APPLICATION NO.	FILING DATE	FIRST NAMED INVENTOR	ATTORNEY DOCKET NO.	CONFIRMATION NO.
10/688,119	10/17/2003	Michael T. Fleury	MPSO-013B1	9234

Office Action Summary

DETAILED ACTION***Claim Rejections - 35 USC § 102***

Figure A: A copy of Figure 6, taken from U.S. Patent No. 5,591,138 (Vaillancourt).

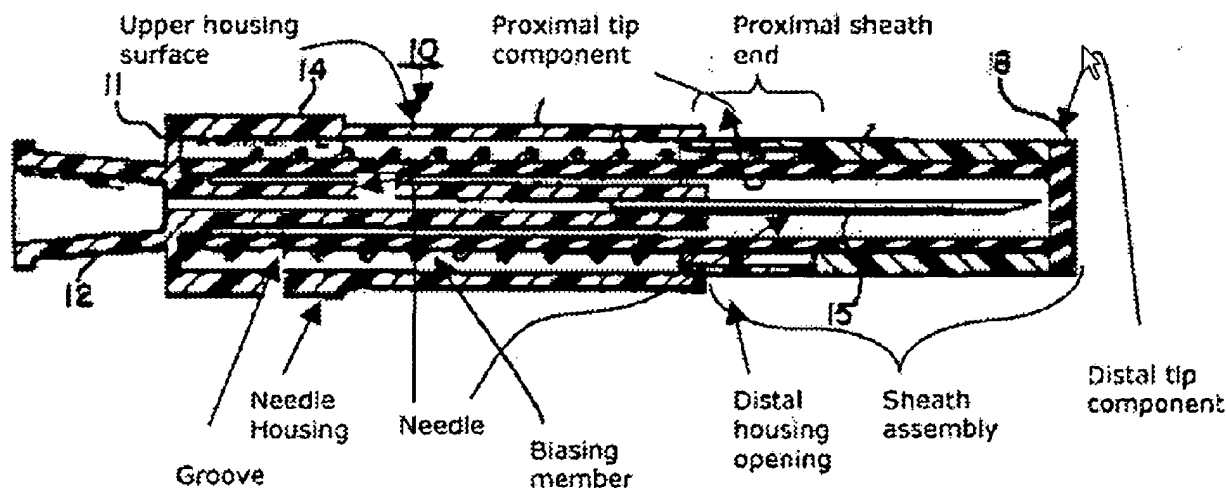
1. Claims 1, 10, 12-16 and 20 are rejected under 35 U.S.C. 102(b) as being anticipated by U.S. Patent No. 5,591,138 to Vaillancourt.

Vaillancourt also shows a trigger member 21. See Figures 1-3. See also col. 6, lines 5-15.
